Belfield/Blackrock to City Centre Core Bus Corridor Scheme Section 146B Request Engineering Technical Note

Job number 268401-00
Date 12 October 2026

This Engineering Design Technical Note has been prepared in support of a Proposed Minor Alteration to the approved Belfield / Blackrock to City Centre Core Bus Corridor Scheme (the Approved Scheme), which is being sought by the National Transport Authority pursuant to Section 146B of the Planning and Development Act 2000 (as amended).

Figure 1: Approved Scheme layout at Rock Road (R118)/Emmet Square/Blackrock Clinic junction

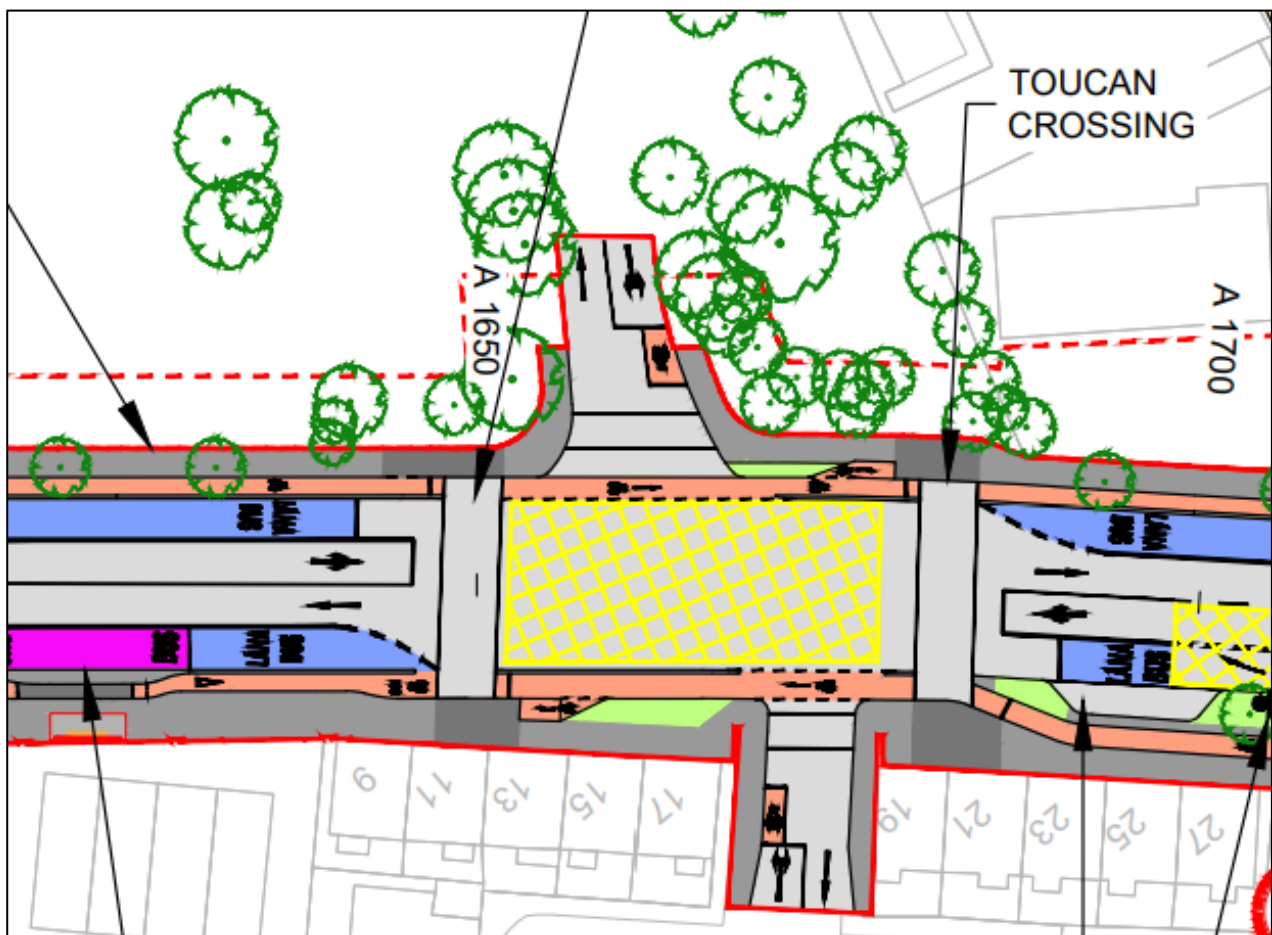
Under the Approved Scheme, the Rock Road (R118) / Emmet Square / Blackrock Clinic junction consisted of a slightly staggered four-arm signalised junction, with toucan crossings provided on both Rock Road (R118) arms of the junction, and signalised pedestrian crossings on the Emmet Square and Blackrock Clinic arms, as presented in General Arrangement Drawing BCIDC-ARP-GEO_GA-1415_XX_00-DR-CR-0005 Revision M01, an extract of which is shown in Figure 1 below:

As part of the Proposed Minor Alteration, this junction will remain a signalised junction, however, it is now proposed to be a three-arm signalised junction, as the Blackrock Clinic entrance has been relocated, and will therefore no longer form the western arm of the junction. This revised junction layout is shown in Figure 2 below. Toucan crossings are proposed on both Rock Road (R118) arms of the junction with a signalised pedestrian crossing proposed on the Emmet Square arm. Bus priority will be provided through the junction, as per the Approved Scheme, as will cyclist infrastructure.

Figure 3: Approved Scheme layout at Rock Road (R118)/Phoenix Terrace

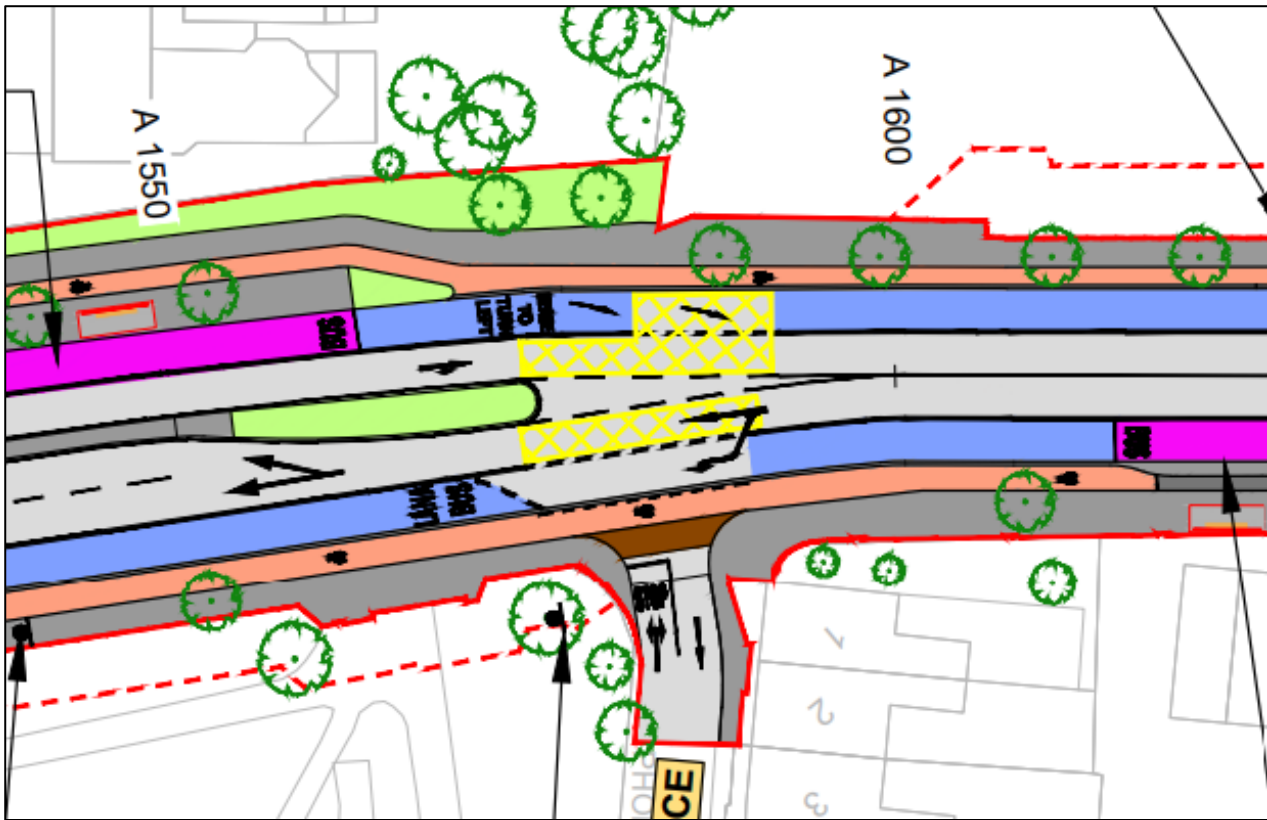
Under the Approved Scheme, the Rock Road (R118)/Phoenix Terrace junction consisted of a three-arm priority junction, with priority provided for pedestrians and cyclists continuing along Rock Road (R118) across the Phoenix Terrace arm and 'Stop' control for general traffic, as shown in Figure 3 below.

As part of the Proposed Minor Alteration, it is proposed to provide a four-arm signalised junction in this location, which incorporates the new as-built Blackrock Clinic entrance. Protection for cyclists is proposed at the junction, in line with layout TL503 from the NTA Cycle Design Manual and the principles of the BusConnects Preliminary Design Guidance Booklet. Separate pedestrian crossings are proposed on all arms of the junction. A dedicated right turn lane for southbound traffic entering Blackrock Clinic is proposed, to connect to the new as-built Blackrock Clinic entrance. A dedicated right turn lane for northbound traffic entering Phoenix Terrace has also been provided. There is a minor stagger between the Phoenix Terrace and new Blackrock Clinic arms of the junction, which this Proposed Minor Alteration will not change. The junction layout proposed as part of the Proposed Minor Alteration is shown in Figure 4 below.

Figure 5: Total Permanent and Temporary Land Take for Approved Scheme and Proposed Minor Alteration

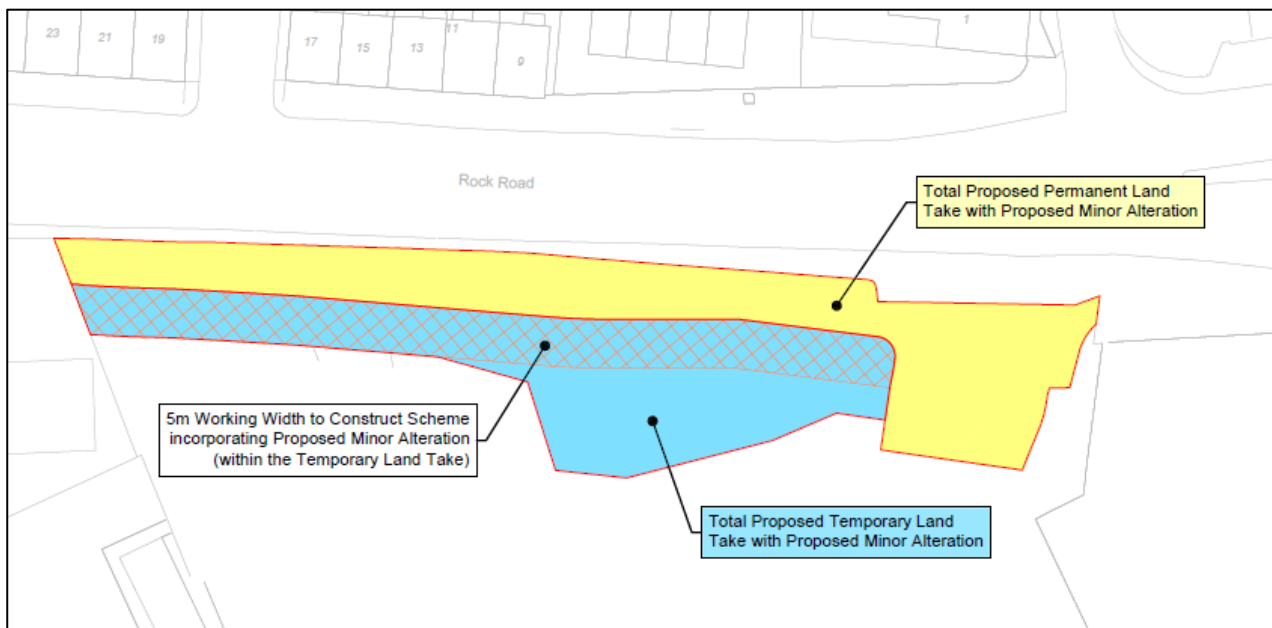
Figure 5 below illustrates the combined total permanent and temporary land take required for the Approved Scheme incorporating the Proposed Minor Alteration. These lands do not include lands previously acquired for the Approved Scheme which are now not required.

Figure 6: Temporary Land take for the Proposed Minor Alteration illustrating the short duration works to the car park

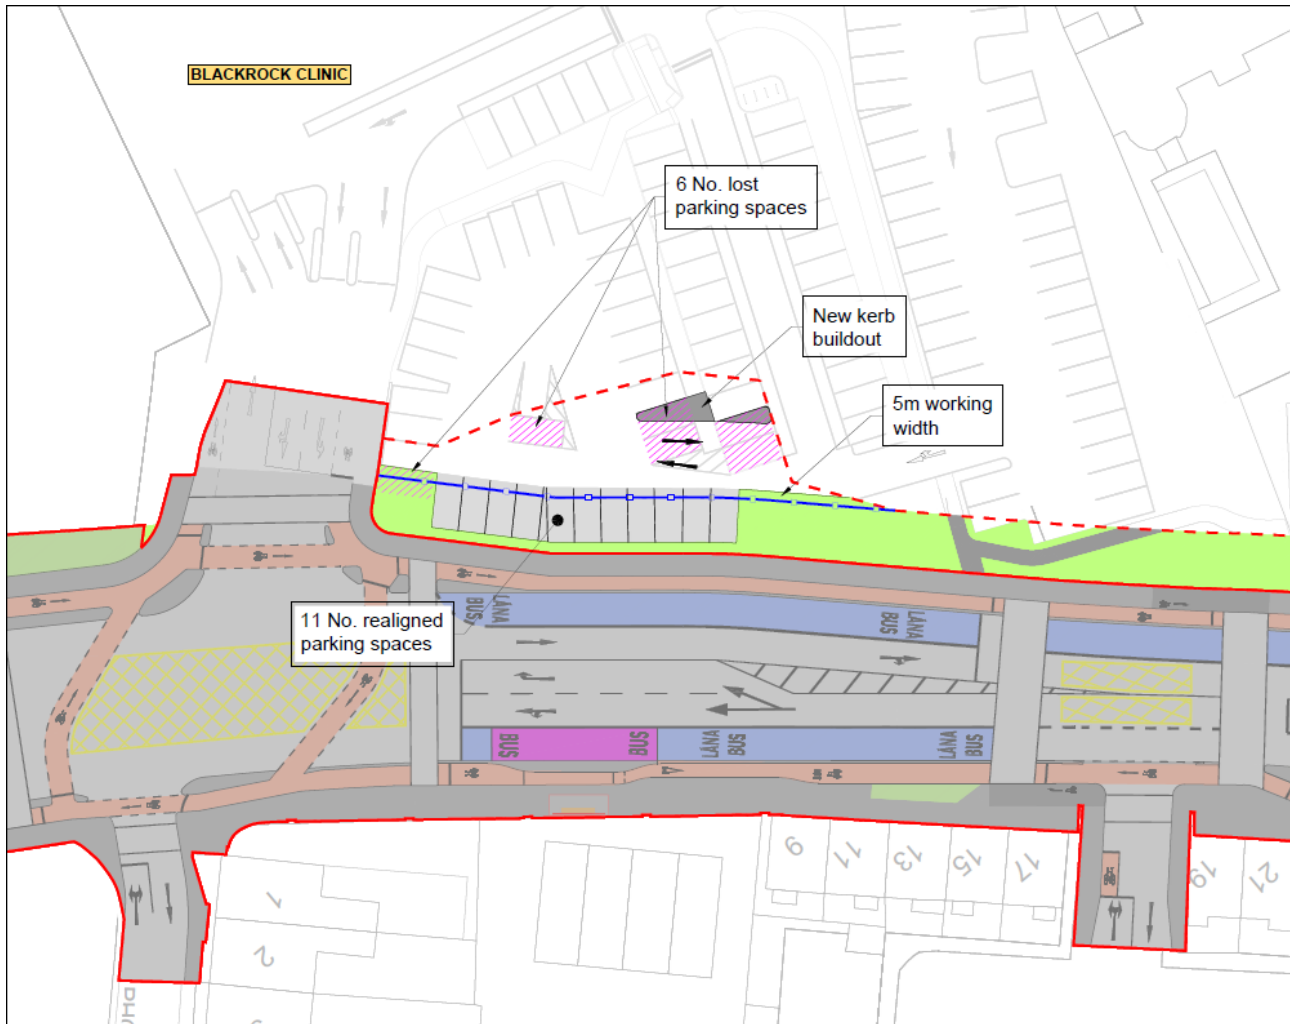
Figure 6 below presents an extract from Drawing BCIDC-ARP-PDV_PD_XX_00-DR-CR-0073-01 and shows typical 5m offset from the proposed site boundary line to enable the construction of the permanent boundary treatment. The area of perpendicular parking along the recently constructed new boundary of Blackrock Clinic shall be relocated to along the future boundary of the Proposed Minor Alteration, requiring the temporary loss of this car parking area during construction.

The remaining temporary land take area is required to carry out any short duration accommodation works necessary to the Blackrock Clinic car parking area to facilitate the construction of the Proposed Minor Alteration. The operation of the remainder of the future car park in Blackrock Clinic can be maintained through minimal and short term civil works such as re-marking of the car park road markings, relocating concrete upstands, relocating signage, etc, all within the proposed temporary land take line and in consultation with Blackrock Clinic.
